Approved Septic System Plan
Howard County Health Department
REVISED

PLAT PLAN
LOT 30
LYNDONBROOK
SITUATED ON
WHITMAN WAY
3RD ELECTION DISTRICT
HOWARD COUNTY
MARYLAND
SCALE: 1"=50' DEC., 2000

REF. F97-126 / SEPTIC REVISED

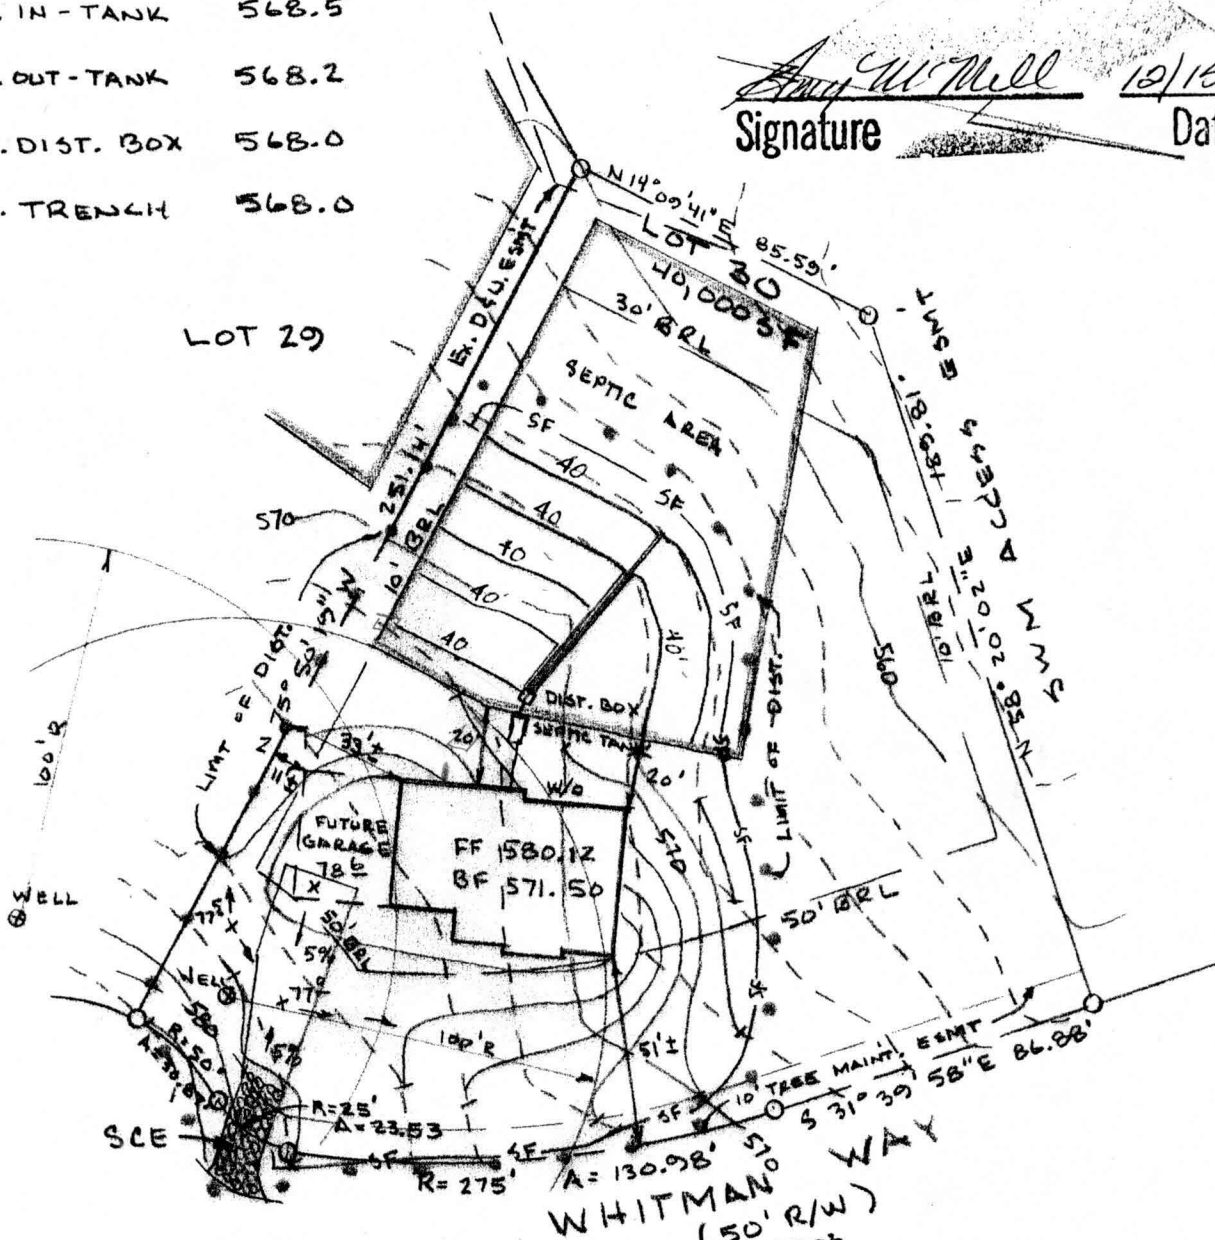
12/7/00
Shown adjustment to SBA OK as
shown. Advised Rob Dorsey that
he should tell homeowners that
they are limited to a 10.0' wide
deck w/ this change. A McMill
